UNITED STATES PATENT AND TRADEMARK OFFICE

APPLICATION NO.	FILING DATE	FIRST NAMED INVENTOR	ATTORNEY DOCKET NO.	CONFIRMATION NO.
10/528,215	03/17/2005	Bernd Salomon-Bahls	11138-017	6269

Office Action Summary

DETAILED ACTION

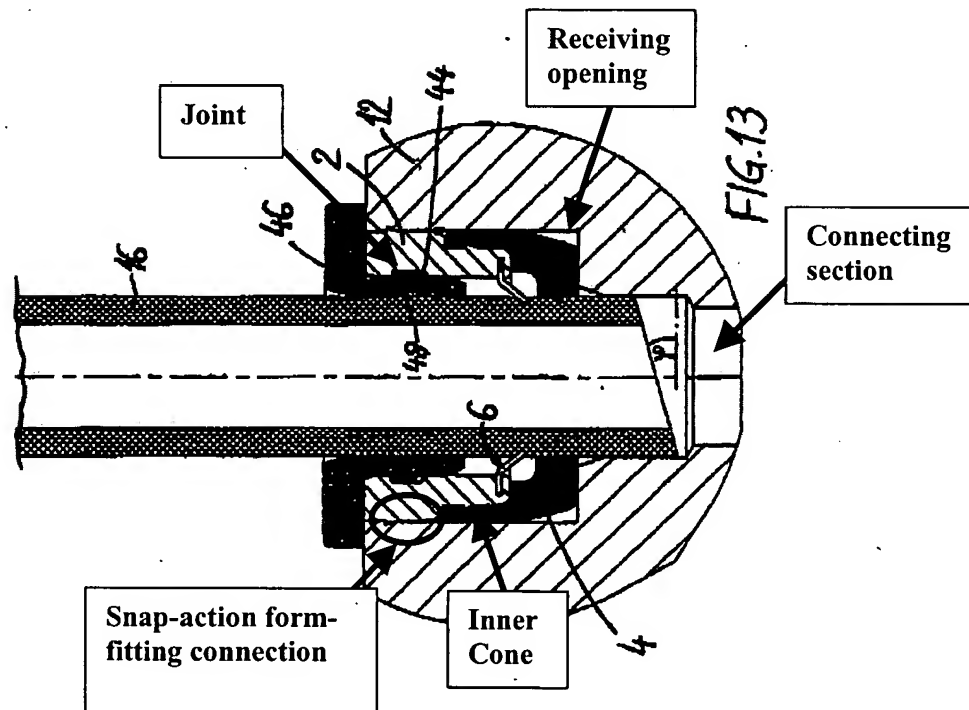
With regard to claim 1 and as seen in Figure 13 below, Salomon-Bahls discloses a connecting device for the plug-in connection of at least one pipeline 16, comprising a housing part 2,12 having at least one receiving opening for the insertion of the pipeline, and a clamping ring 4, which is arranged in the receiving opening and, in order to lock the pipeline in place, interacts with an inner cone of the housing part, the housing part being made in two parts from a base part 12 and an insert part 2, which is connected to the base part via a snap-action form-fitting connection and which has the inner cone, and the insert part having a dirt seal 46 for resting on the circumference of the inserted pipeline, and the dirt seal consisting of a second, relatively soft and elastic plastic material, is molded directly onto it as a single piece with a cohesive material joint therebetween.

Salomon-Bahls discloses that the insert part is of a metal material and not a plastic material. However, it would have been obvious to one of ordinary skill in the art at the time the invention was made to have fabricated the insert part with plastic because it has been held to be within the general skill of a worker in the art to select a known material on the basis of its suitability for the intended use as a matter of obvious design choice. In re Leshin, 125 USPQ 416.

With regard to claim 7 and as seen in Figure 13 above, Salomon-Bahls discloses wherein the housing can be connected to a further assembly part via at least one connecting section.

With regard to claim 8 and as seen in Figure 13 above, Salomon-Bahls discloses the connecting section being designed as a pipe attachment for insertion into the receiving opening.
